Product Change Notice (PCN)

PCN Number: PCN-0539021R-01

Product(s) Affected: CBL-UA-MUB-1

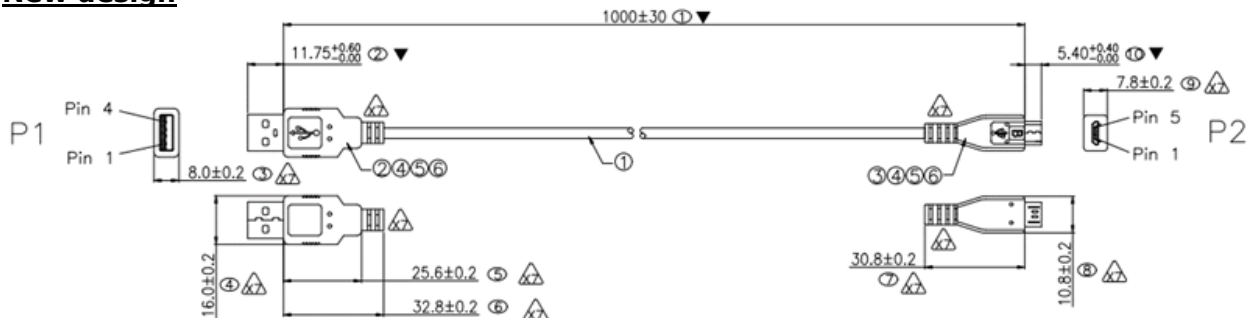
Reason(s) for Change: broken tooling for overmold.

Description of Change: dimension modifications to overmolds as shown below:

Old design

New design
